ADDENDUM NO. [1] Date: April 1, 2022

**RE: Physical Plant Renovation
 Western Technical College
 505 9th Street North
 La Crosse, Wisconsin
 HSR Project 21065**

**FROM: HSR Associates, Inc
 100 Milwaukee Street
 La Crosse, WI 54603
 (608) 784-1830**

A100

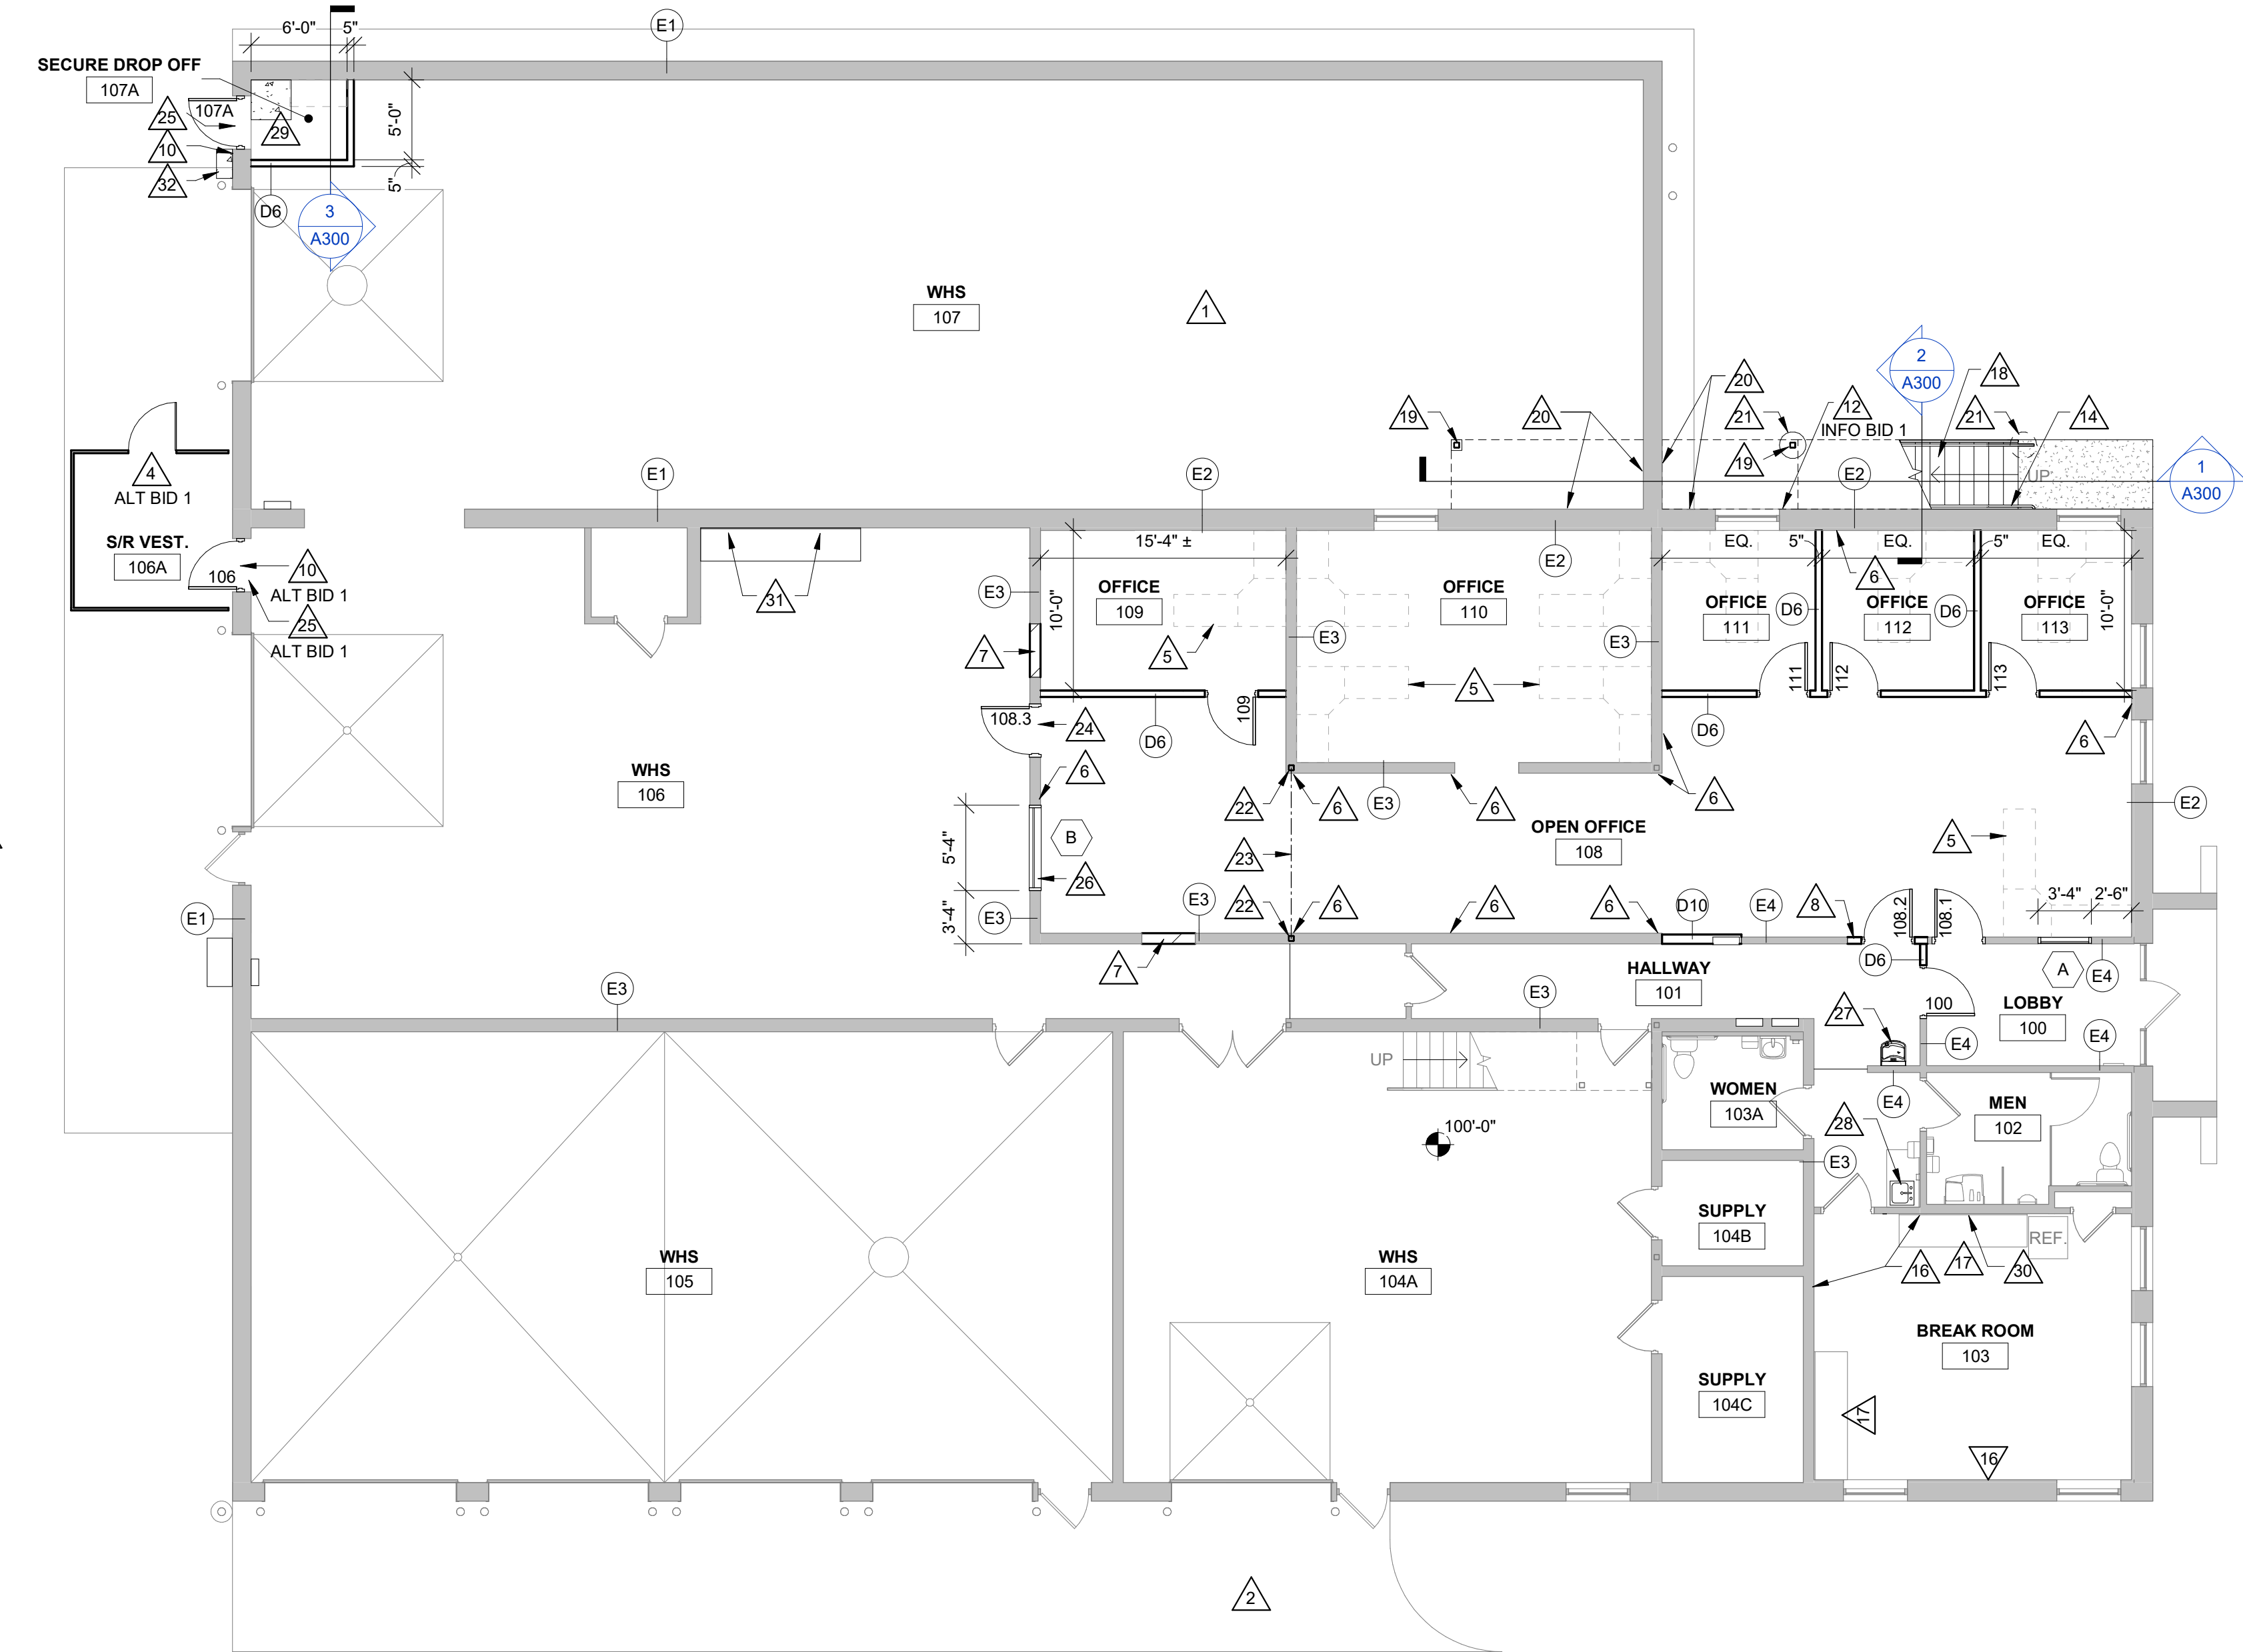
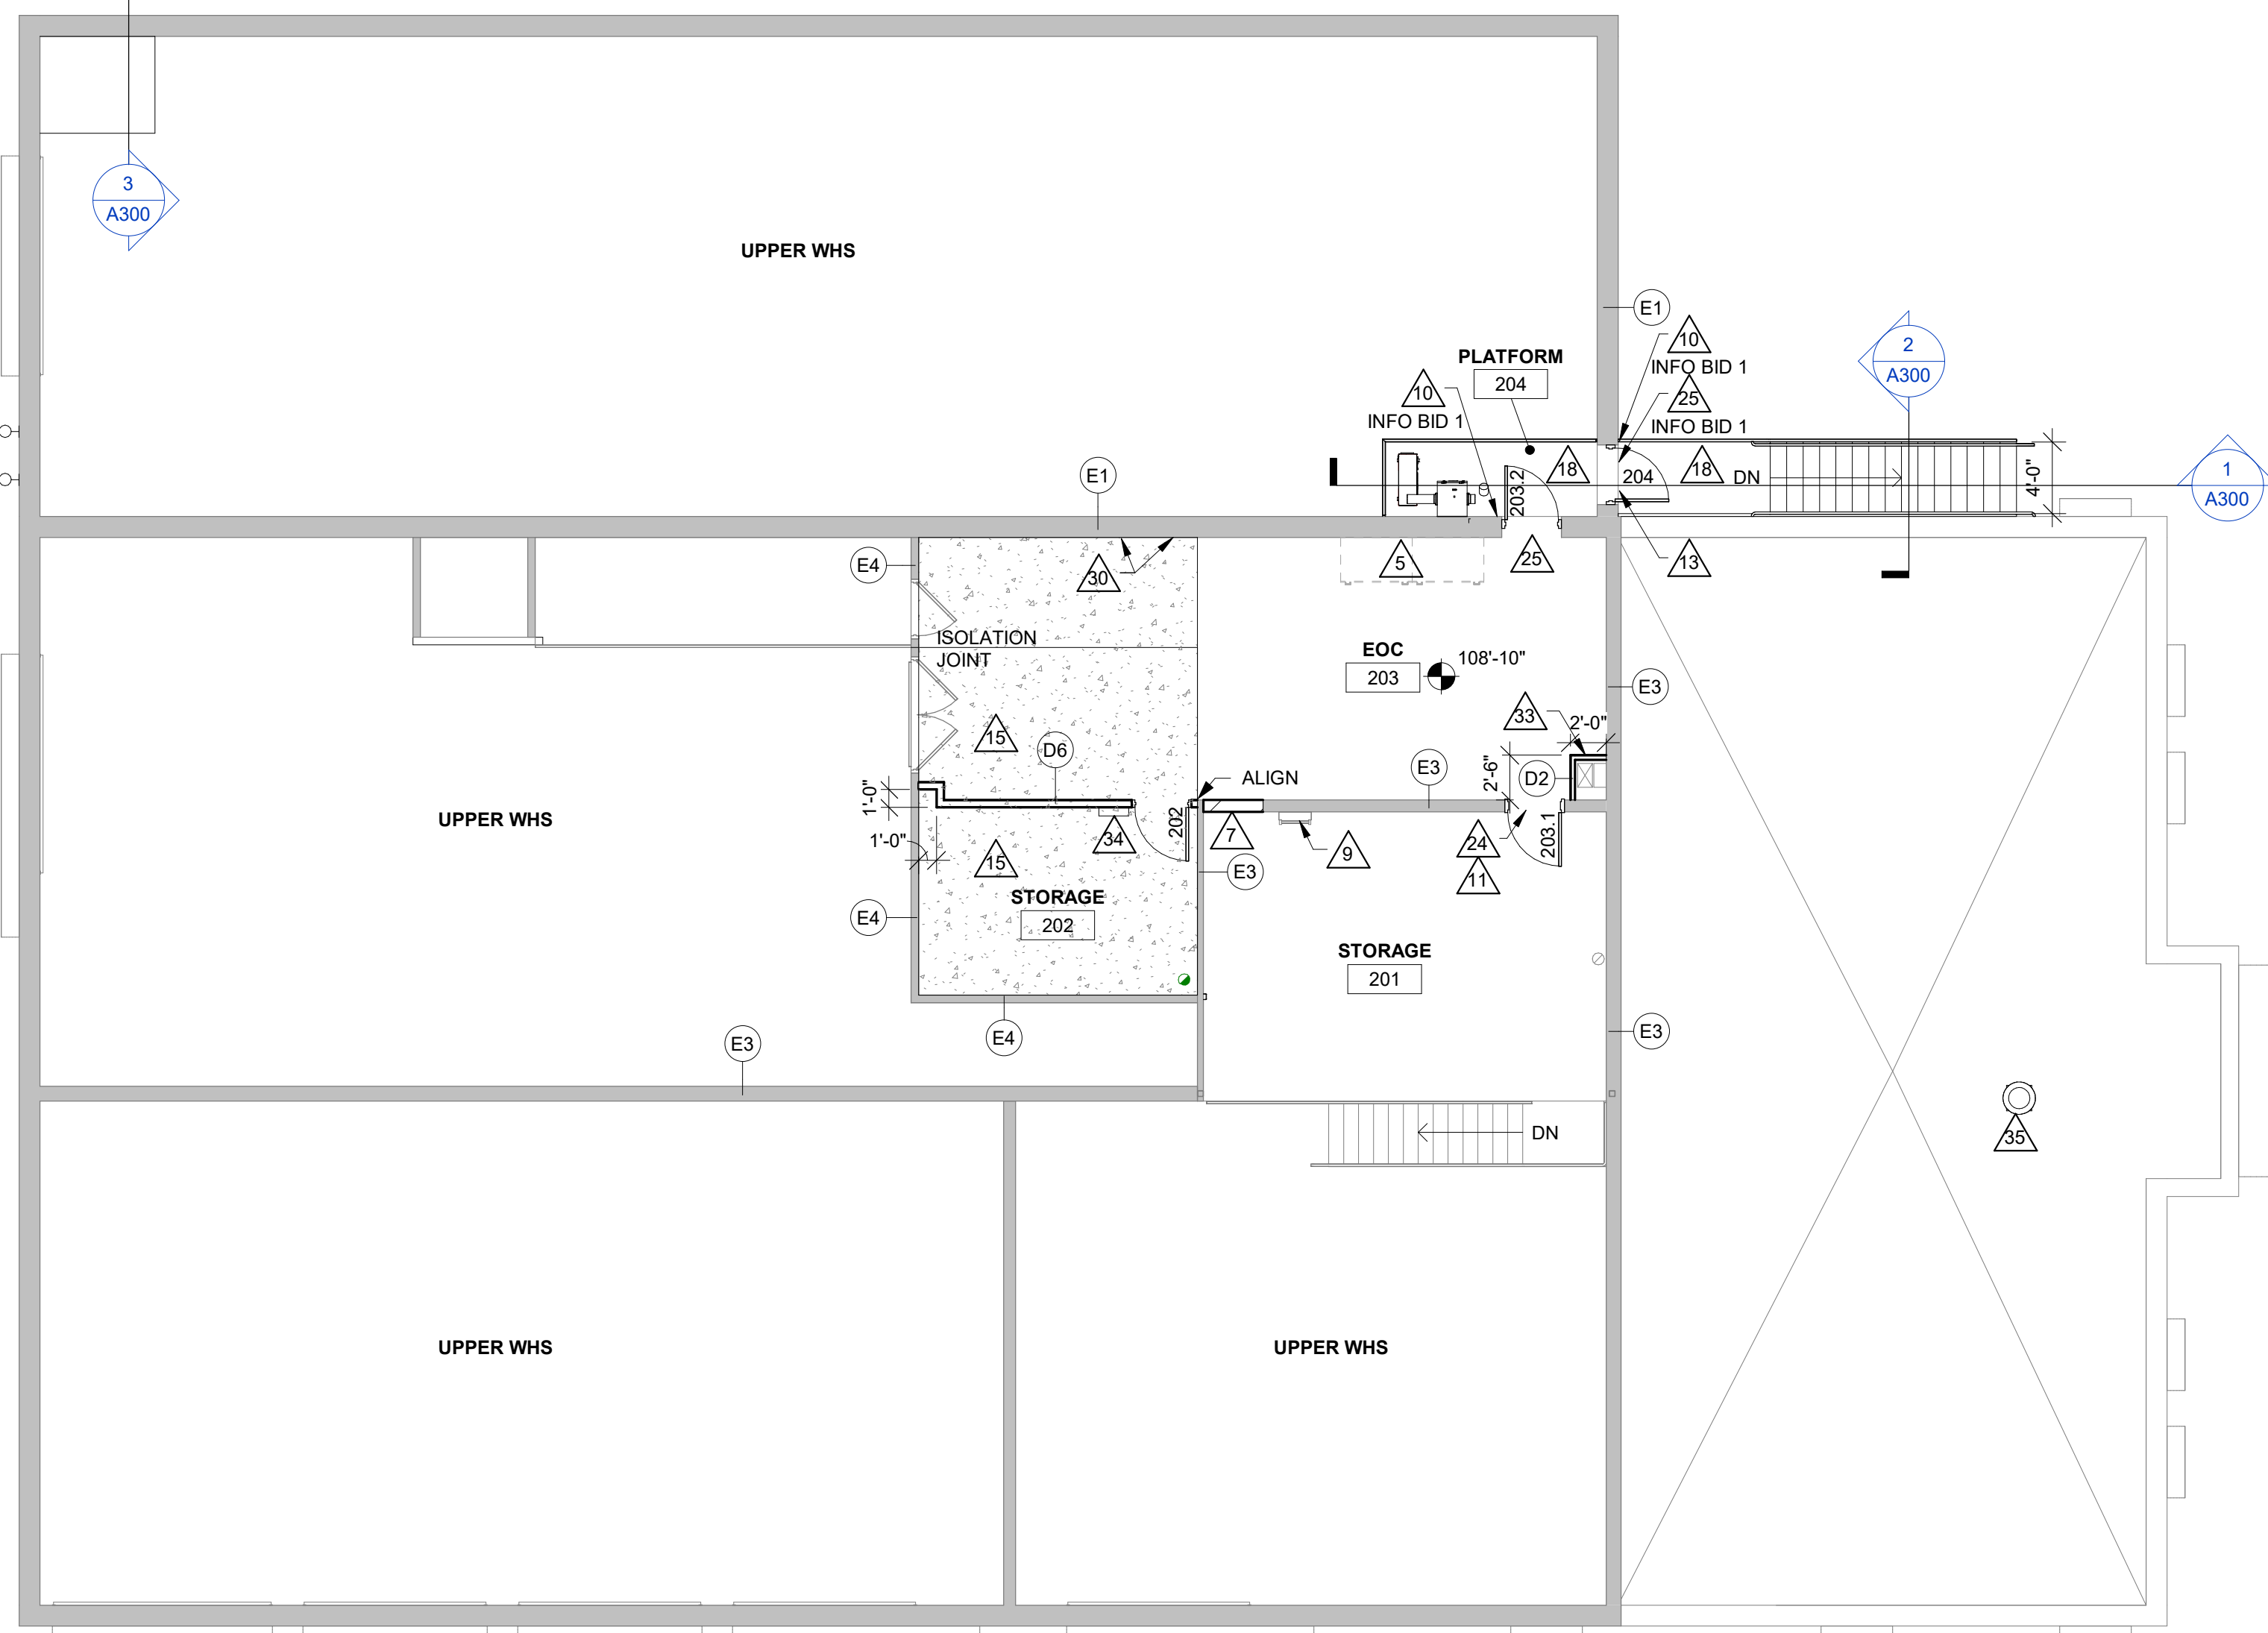
7. Sheet A100 REMODEL PLANS
 - a. See 30"x42" sheet attached hereto.
 - b. Keynote 14 updated.

- 11 TOOTH IN MASONRY AT NEW DOOR OPENING
- 12 PATCH EFS AT REMOVED DETAIL ABOVE WINDOW
- 13 PATCH EFS AT NEW MECH
- 14 1 1/4" DIA. (16# O.D.) STEEL PIPE HANDRAIL W/ BRACKETS ATTACHED TO CMU (PAINT) PATCH EFS AS REQ'D. RETURN RAIL TO WALL AT END. INFO BID 1

A110

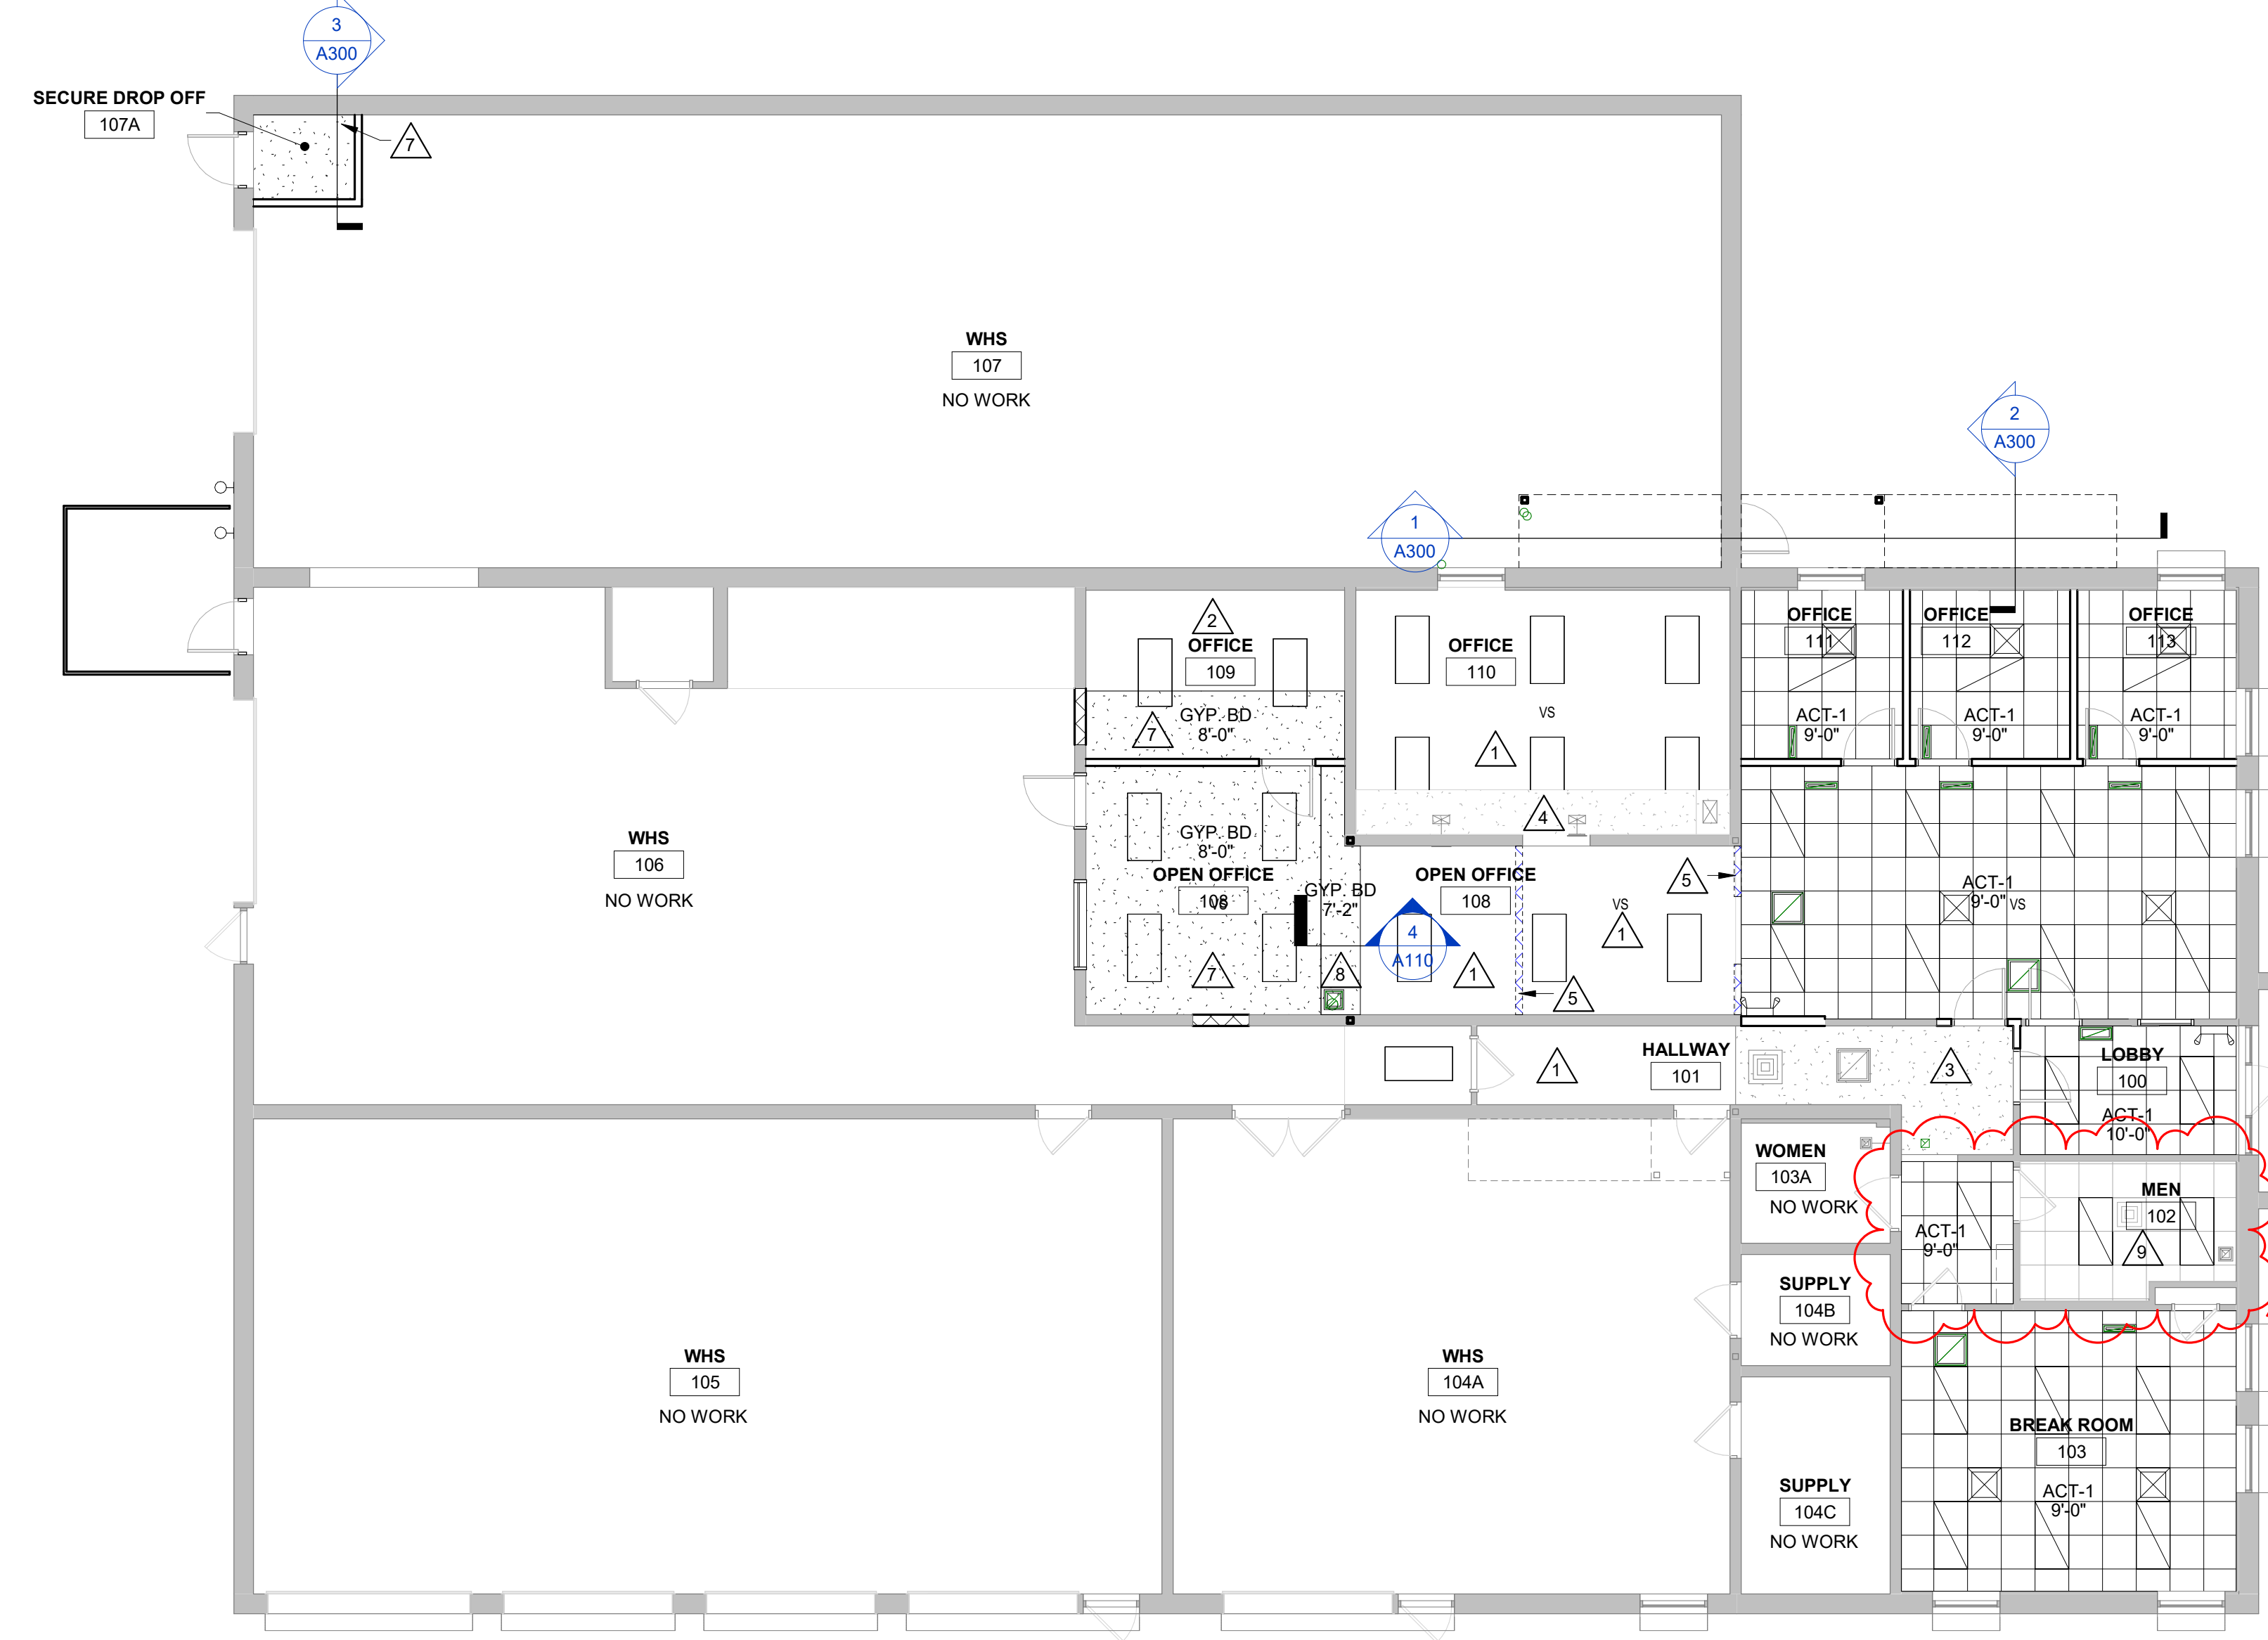
8. Sheet A110 REFLECTED CEILING PLANS
 - a. See 30"x42" sheet attached hereto.
 - b. New ACT-1 ceiling in Hallway 101.
